Access Compliance Report

Public Rights-of-Way

(Curb Ramps)

Intersection ID: 27788	Main Street: PROVIDENCE_RD	Cross Street: PROVIDENCE_COUNTRY_CLUB_DR	Location: NW
ADA ID: 69FD06782BCB	Ramp Type: BlendTrans1	Initial Pass/Fail: Fail	Overall Compliance: No
		Severity Score: 12.5

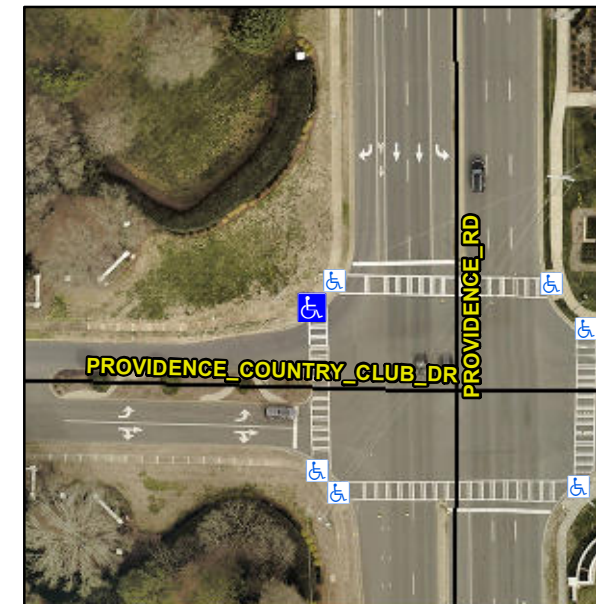
Not Found, R304.5.3

Compliance	Description	Data	Compliance	Description	Data
N/A	Ramp Length (in)	39.0	Yes	BlendTrans Slope (%)	2.2
Yes	Ramp Width (in)	56.0	No	BlendTrans XSlope (%)	6.0
N/A	Flare Type LT	N/A	N/A	Flare Type RT	N/A
N/A	Flare Slope LT (%)	N/A	N/A	Flare Slope RT (%)	N/A
N/A	Flare Traversable LT?	N/A	N/A	Flare Traversable RT?	N/A
N/A	Landing Length (in)	N/A	N/A	DWS Provided?	N/A
N/A	Landing Width (in)	N/A	N/A	DWS Contrast?	N/A
N/A	Landing Slope (%)	N/A	N/A	DWS Length (in)	N/A
N/A	Landing X Slope (%)	N/A	N/A	DWS Full Width?	N/A
N/A	Landing Curb? (Y/N)	N/A	N/A	DWS Offset (in)	N/A
N/A	Shared Landing?	N/A			
N/A	Gutter Ponding?	N/A	N/A	Gutter Slope (%)	N/A
N/A	Gutter Lip Ht (in)	N/A	N/A	Gutter X Slope (%)	N/A
N/A	Painted X Walk1?	Yes	N/A	Painted X Walk2?	N/A
	X Walk 1 Direction	To S		X Walk 2 Direction	N/A
	X Walk 1 Width (in)	103.0		X Walk 2 Width (in)	N/A
	X Walk 1 Slope (%)	2.2		X Walk 2 Slope (%)	N/A
	X Walk 1 X Slope (%)	5.6		X Walk 2 X Slope (%)	N/A

Remove & Replace Curb Ramp With Two New Directional Ramps or Equivalent.
